Amendments to the Site Certification Application for the Indiantown Cogeneration Facility

Prepared for:
Indiantown Cogeneration, L.P.
P.O. Box 1799
19140 SW Warfield Blvd.
Indiantown, FL 34956

Prepared By:
Earth Tech
196 Baker Avenue
Concord, Massachusetts 01742

December 1999

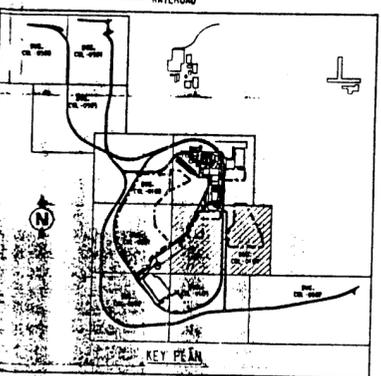
2.3 Site Plan Changes Reflecting As-Built Conditions

Two truck scales were added to the Facility: one at the north end near the cooling tower, and one to the southeast of the power block near the wastewater storage pond. These scales are used for weighing the Facility's ash. The scales are also used to

weigh other bulk materials (e.g. lime) on-site to assist with documentation of on-site storage quantities. This is consistent with Condition of Certification II. (6)B.4. that requires ICLP to detail the amount and type of materials produced at the site. The locations of the scales are shown on the site plan that is in Attachment C.

Experience at the Facility revealed that environmental benefits would be realized by adding pavement to certain areas near the lime storage system, and around the power block, in the area between the baghouse and the existing roadway. This paving was installed as a pollution prevention step. Paving allows superior control of runoff so as to ensure proper collection and treatment of runoff from the lime storage system prior to release into the environment. This prevents potentially high pH water from entering natural waterbodies. In addition, areas at the north end of the cooling tower and around the new scales are paved. These additional areas are shown on the as-built site plan included as Attachment C.

An outdoor open-shed area has been added to the warehouse to provide adequate storage for ancillary equipment and replacement parts that are necessary to ensure the careful and reliable operation of the Facility. The warehouse addition has a footprint of 1,000 square feet and is also highlighted on the Site Plan included as Attachment C. Also, a small office (about 500 square feet) for the water treatment system has been located adjacent to the existing softener building.

office space to support ICLP's management team and the systems needed for the smooth operation of the Facility. This building is highlighted on the Site Plan included as Attachment C, and is scheduled for construction in the spring of 2000.

PROPOSED P.D RAILCAR PNEUMATIC CONVEYING SYSTEM P & ID U.S. GENERATING INDIANTOWN, FL

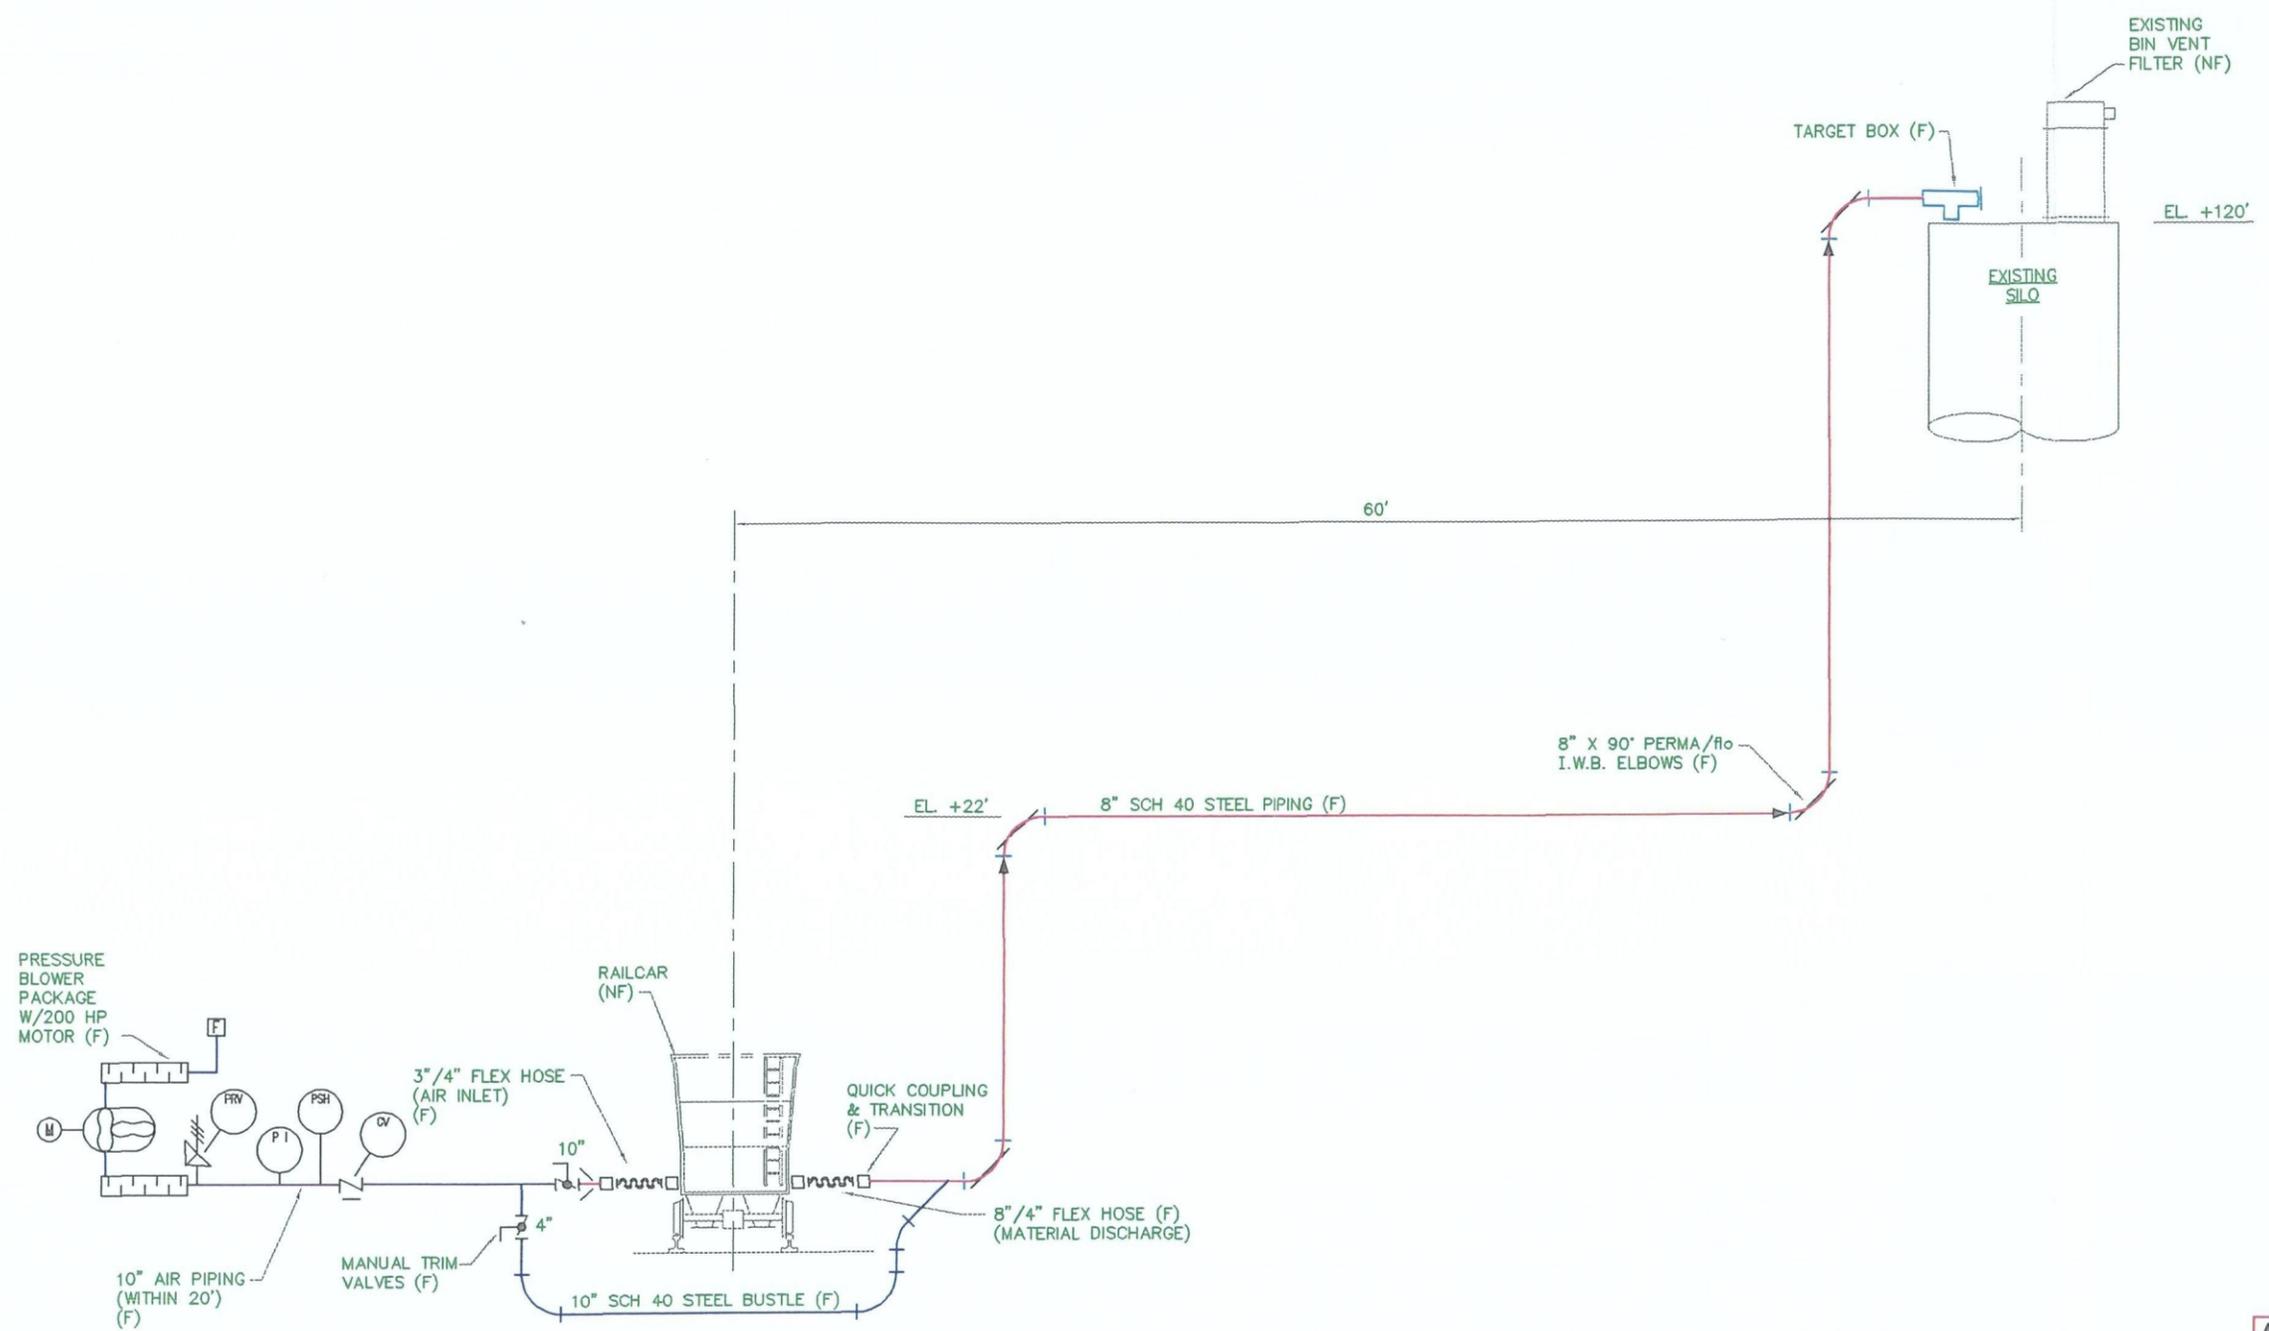
The original site certification authorized the delivery of lime by truck or railcar. The Facility was built with facilities for truck unloading of lime, with allowances in the design for the addition of a rail car unloading system in the future. ICLP now plans to build the rail unloading system for lime. The system is shown on the Piping and Instrumentation Diagram included in Attachment C.

The new railcar lime unloading system will have no impact on air quality at ICLP. The system uses the same emission point, and the same bin vent filter, as the current system. The transfer of lime is performed pneumatically through closed systems. This is an improvement over the rail transfer system originally proposed. No change is required to the PSD or Title V air permits, or the Conditions of Certification.
